REVISIONS				REVISIONS				REVISIONS			
Date	Rev	By	Description	Date	Rev	By	Description	Date	Rev	By	Description
16.09.2016	P 1	GK	PLANNING ISSUE								
21.11.2016	P 2	GK	PLANNING ISSUE								
29.03.2017	P 3	GK	PLANNING ISSUE

Job Title 1602 - 182_184 High Holborn		Client Covent Garden Investment S.A.R.L
Drawing Title PROPOSED SEVENTH FLOOR LAYOUT		Drawing Number & Revision HH-P-20-07-01-01_P3
Scale (at A0) 1 : 100@A1	Date Amended 29.03.2017	Amended By GK
Checked Checker	Date Created	Drawn By Author

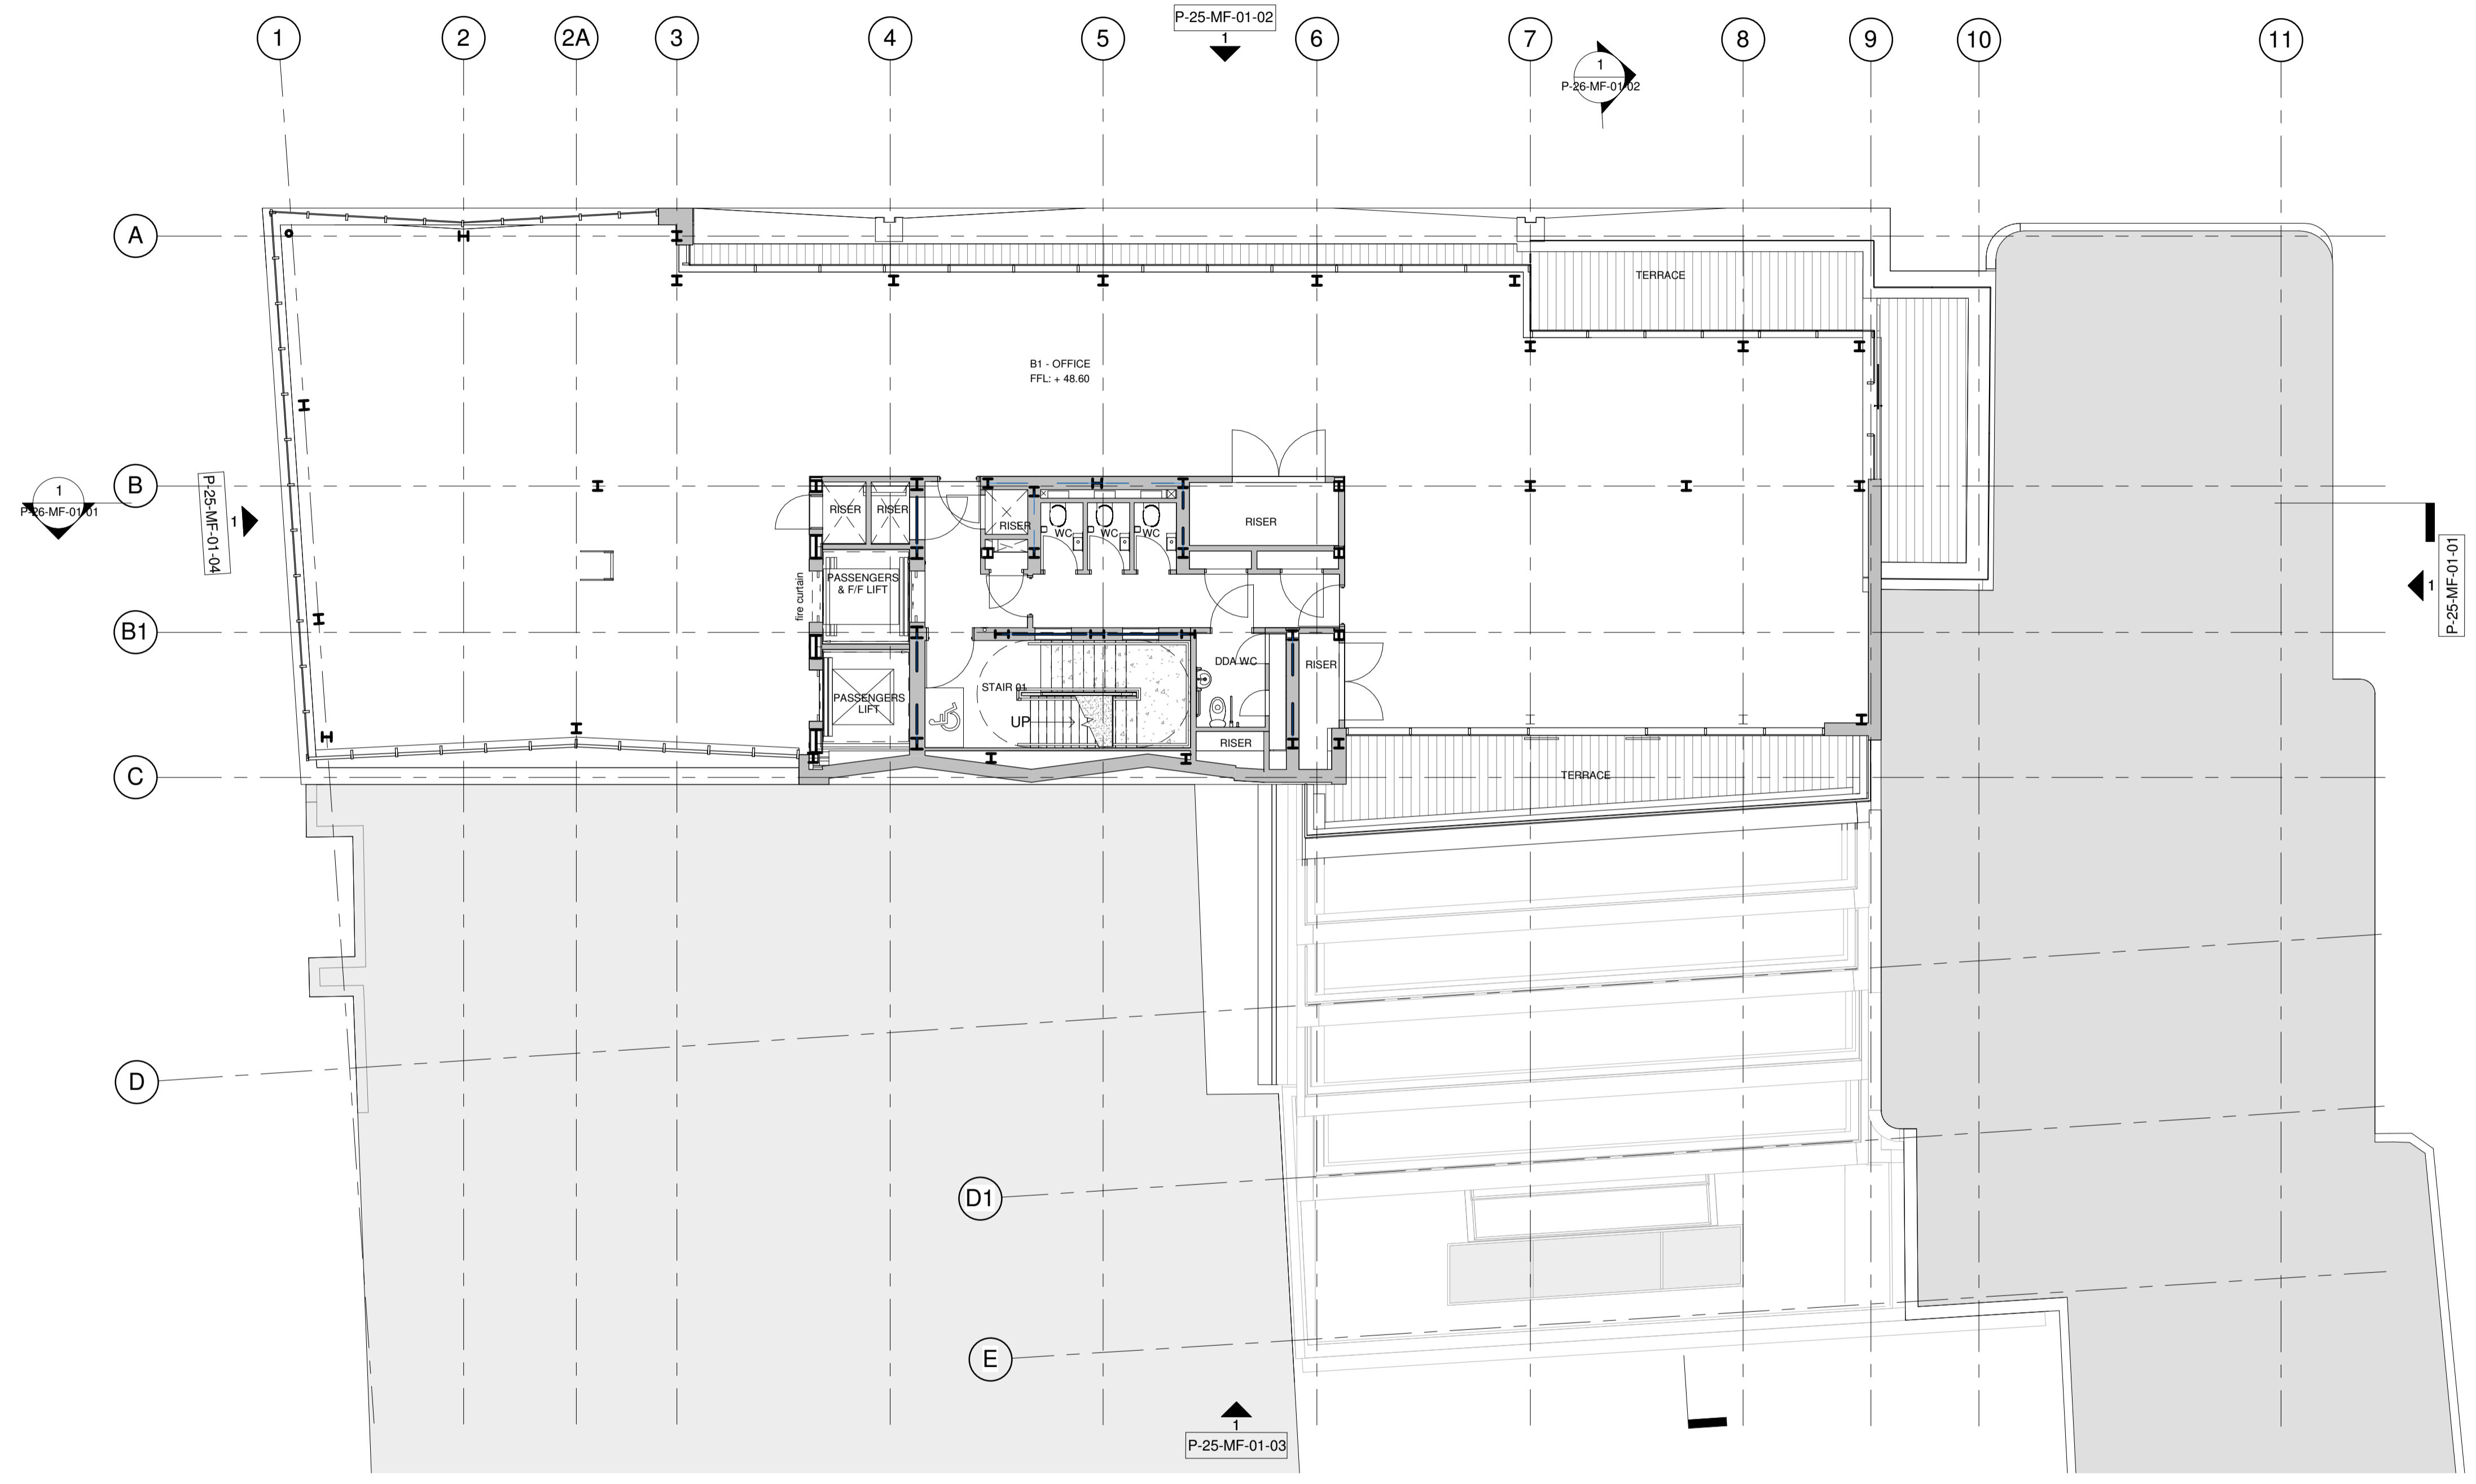
- Elimination of light wells to rear of ground floor as ground louvers were made redundant according to the latest MEP design.
- Reduction of the extent of glass balustrade along Smart's Place elevation for ease of maintenance.
- Level 7 NW corner elevation has been recessed to allow space for abseiling and avoid any over sailing above neighbour's property.
